RESOLUTION APPROVING AMENDMENT TO THE "PUD" CONCEPTUAL
PLAN FOR THE BUTLER MANSION AT 2633 FLEUR DRIVE

Butler Mansion PUD Amendment - 2633 Fleur Drive

ZON2006-00029

APPROVAL of a request from KN Butler, LLC (owner) represented by Liz Newell and John Kragie to amend the Butler Mansion PUD Conceptual Plan for property located at 2633 Fleur Drive to allow construction of a building addition and off-street parking to the existing mansion used for commercial offices, subject to the following conditions: (ZON2006-00029)

WEST ELEVATION
SCALE: 1/8" = 1'-0"

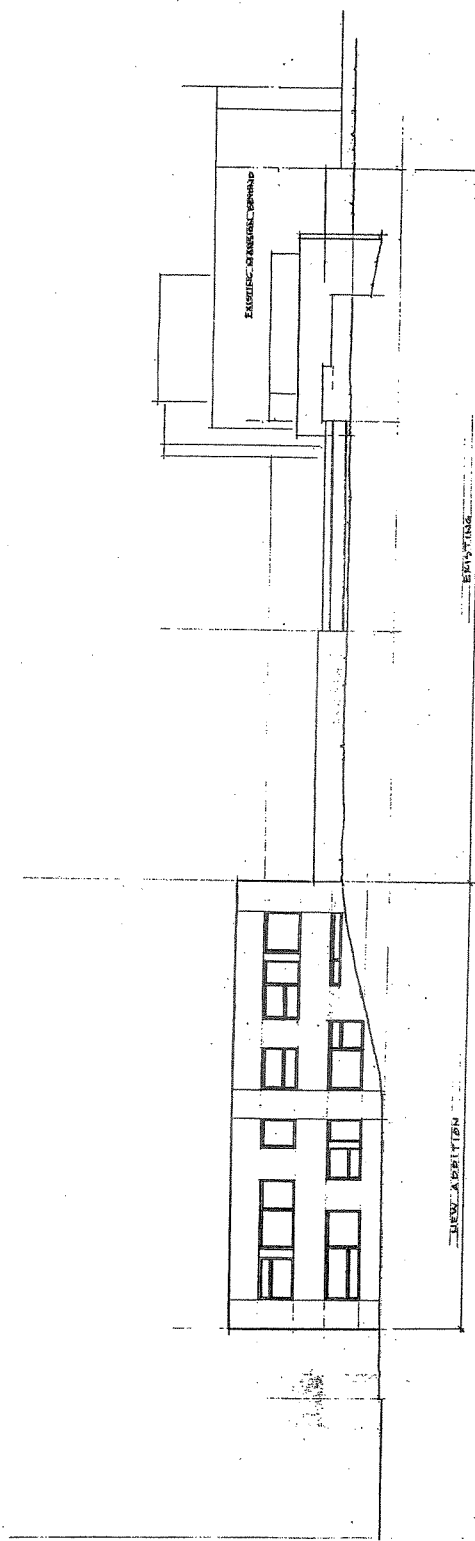
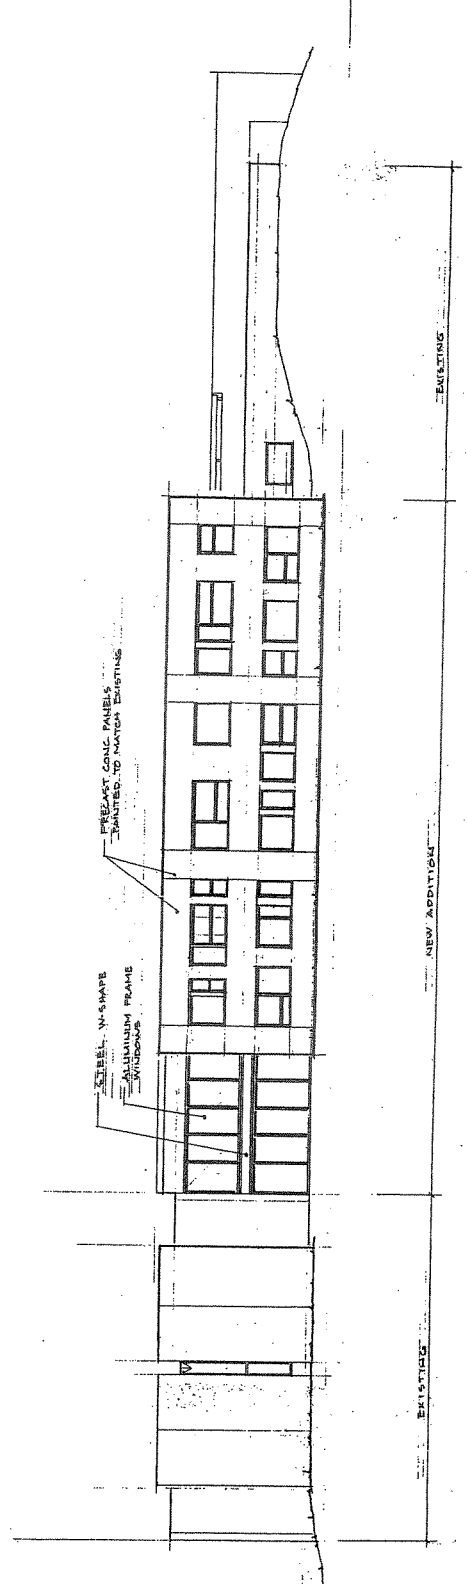
south and east sides of the addition would adjoin the existing structure. According to the elevations, the addition would be sided with precast concrete panels painted to match the existing structure.
